**PART 36  
PERMIT  
APPLICATION**

**RE: East Blanco Field Produced Water Reuse Facility Permit Application Attachment**

EAST BLANCO FIELD PRODUCED WATER REUSE FACILITY PROJECT  
ENGINEERING DRAWINGS FOR  
LOCATED IN RIO ARRIBA COUNTY, NEW MEXICO

**500 FOOT SETBACK FROM  
PROPOSED FACILITY BOUNDARY**

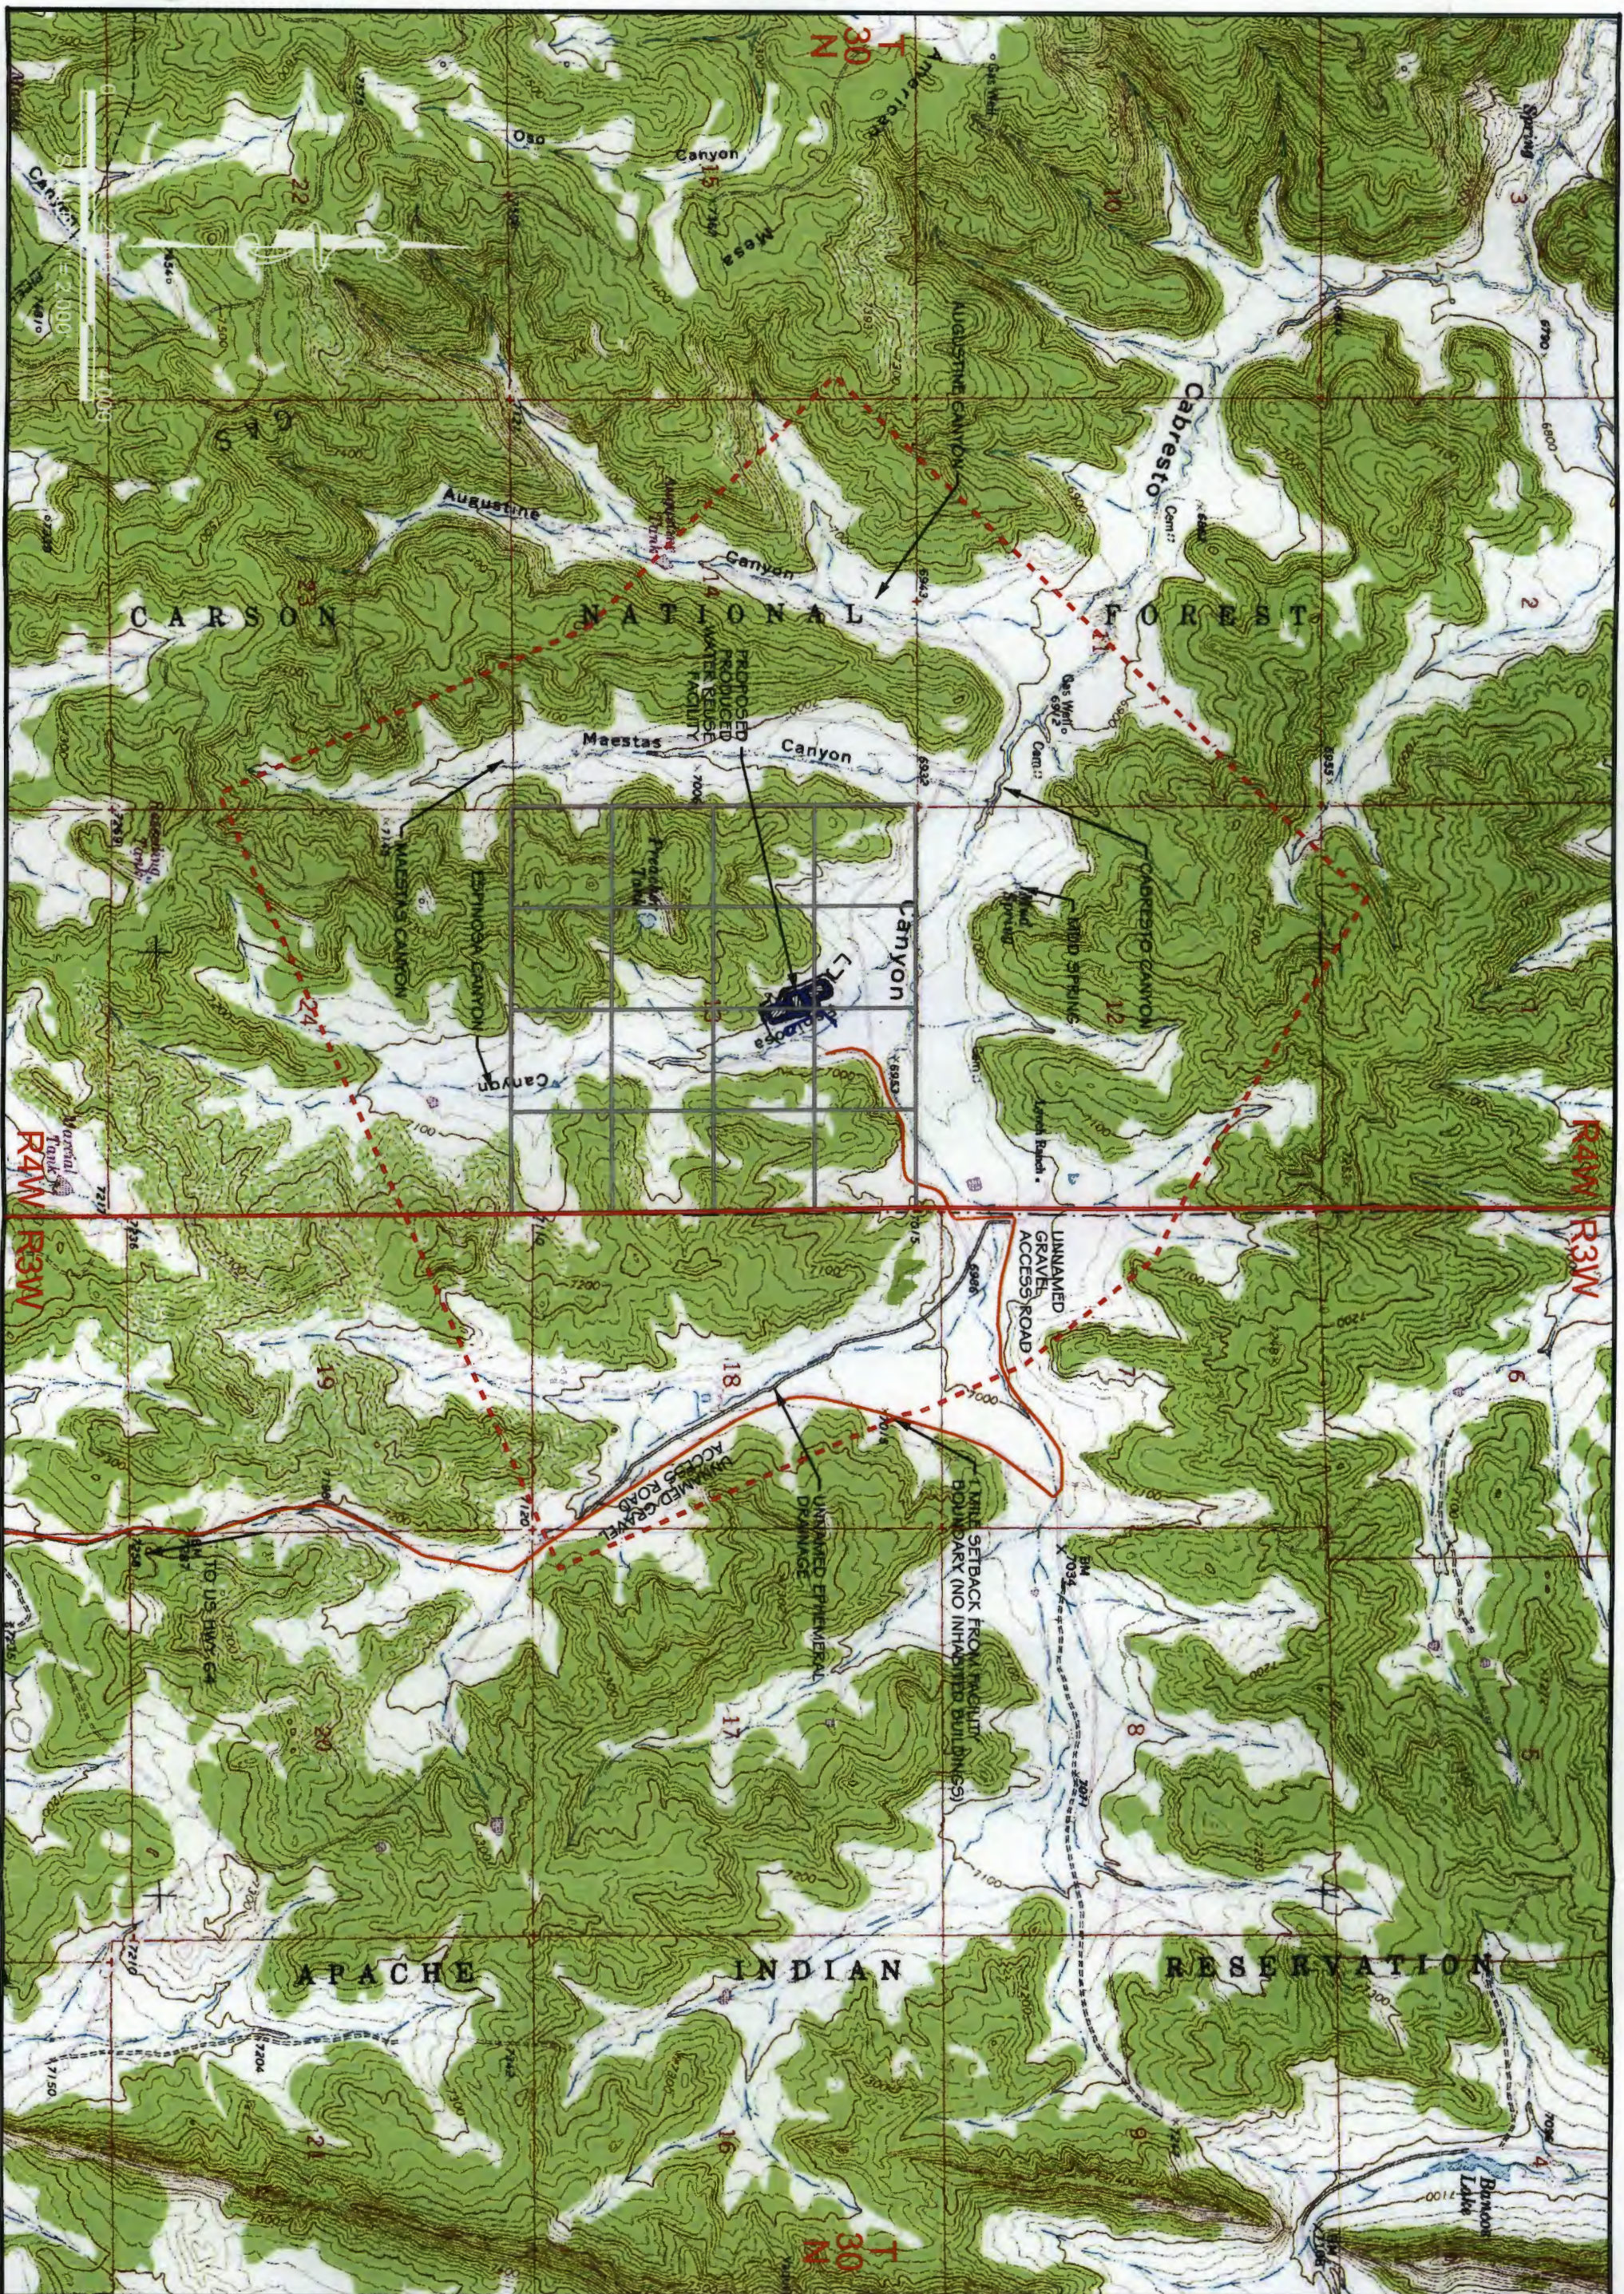
The last sentence in the response provided for the third bulleted provision, Section 19.15.36.13.B.5, states "Exhibit 4 provides a 500 foot setback line from the proposed facility." In order to properly assess and demonstrate setbacks to the facility, a facility perimeter or boundary must be established.

*The proposed fence surrounding the facility will serve as the facility boundary. This has been updated on the corresponding exhibits. Exhibit 5 has been altered to include the topographic map instead of the aerial image. This extent of this exhibit includes all areas within 1-mile of the facility boundary. The text has been updated to reflect this change.*

PLAN VIEW - PIPE MAIN TO PUMPING STATION (D-1)

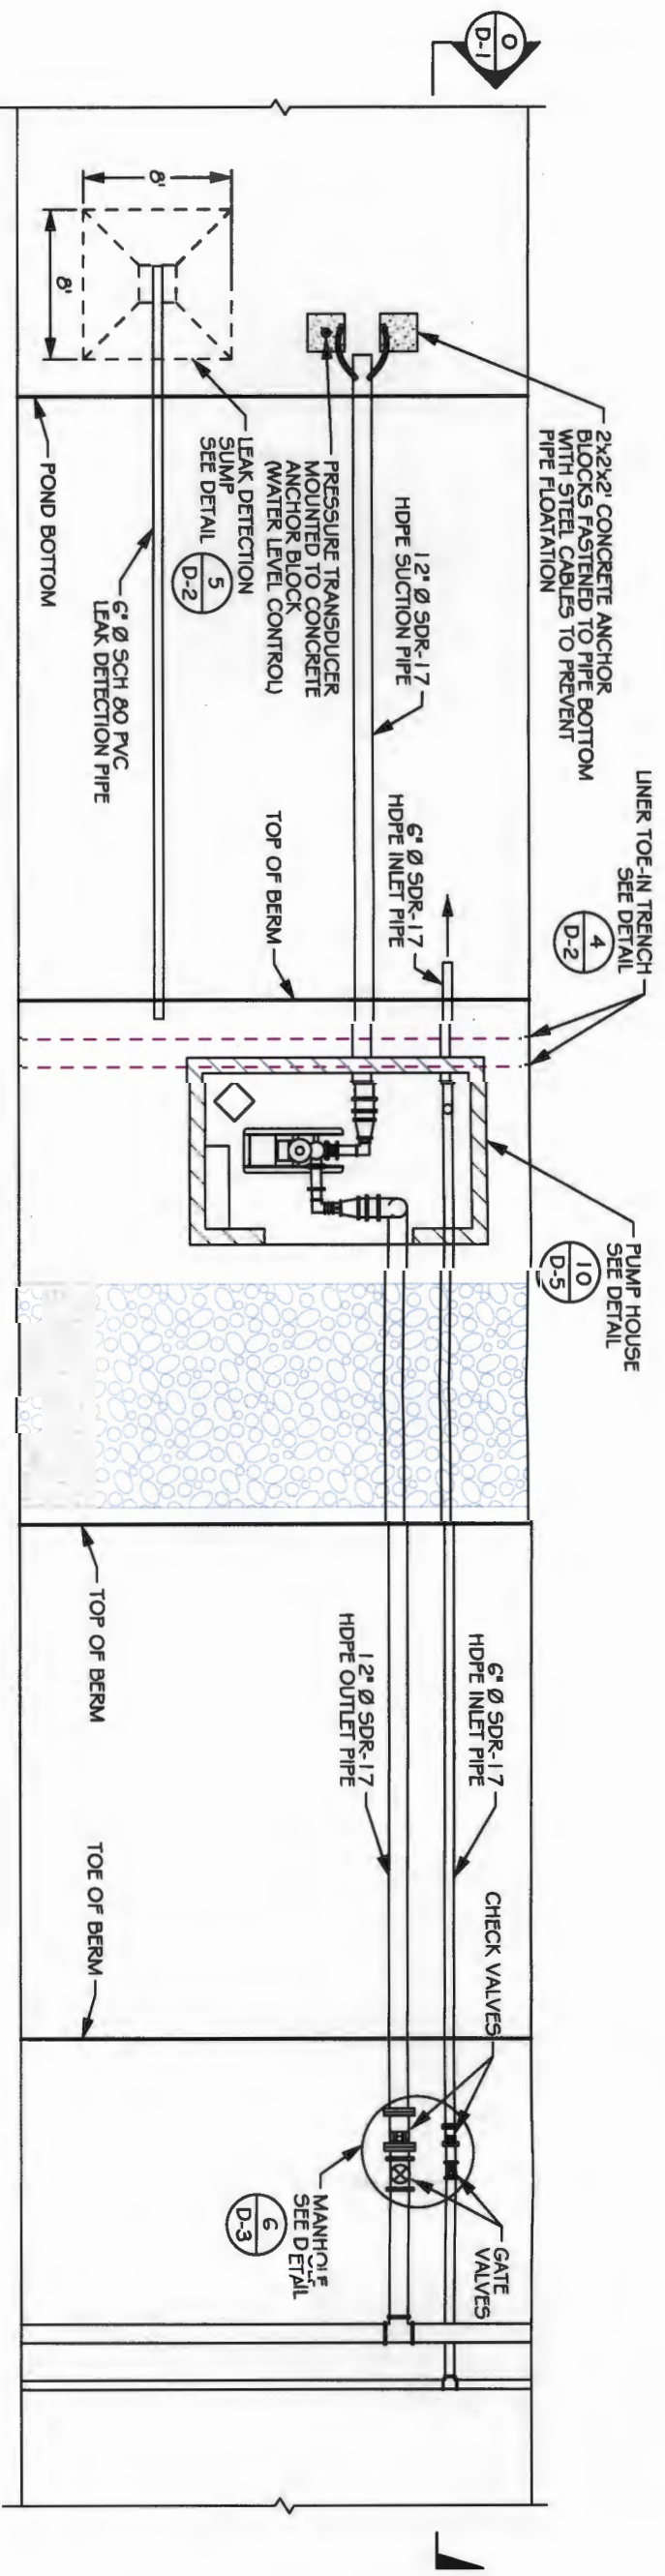
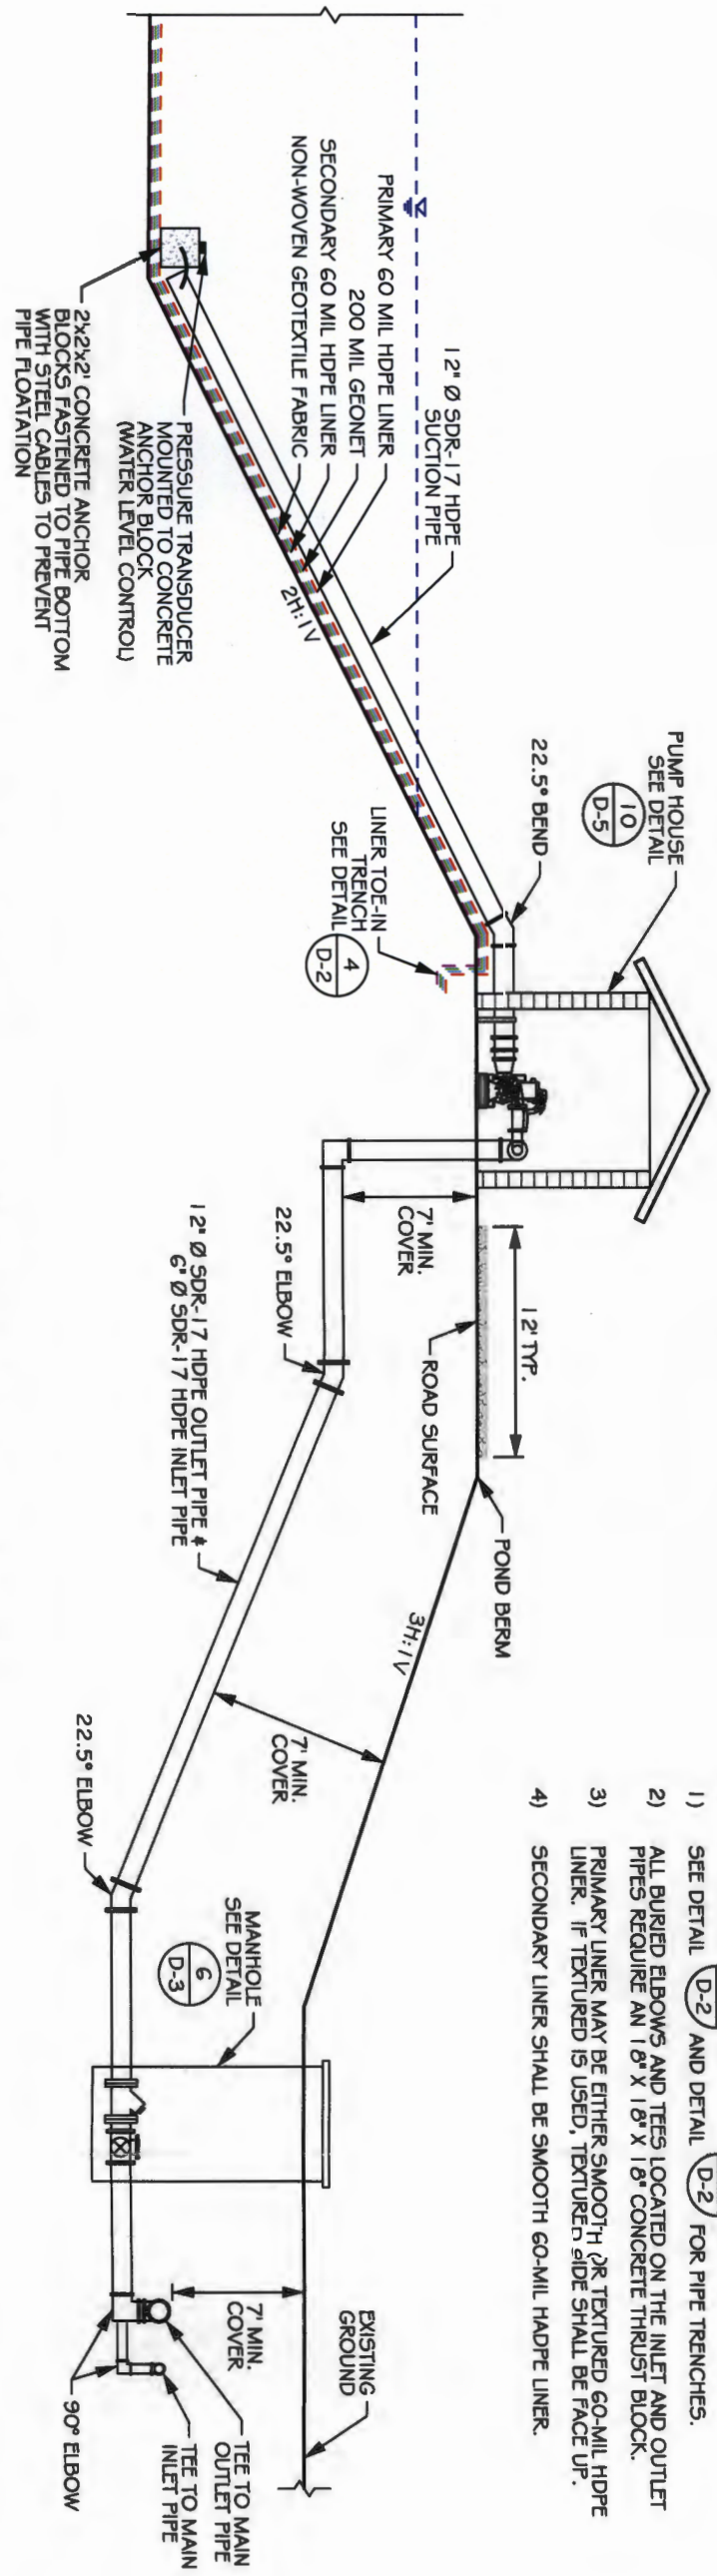
**Sheet D-1, Pipe System Detail, Detail O/D-1:**

*Within the Engineering Drawings located in Appendix A, the "collection" lines have been renamed as "outlet" lines, and the "supply" lines have been renamed as "inlet" lines. As shown in on Sheet D-1 of the Engineering Drawings, a 6-foot diameter steel culvert has been included in the design to act as a manhole for access to the valves.*
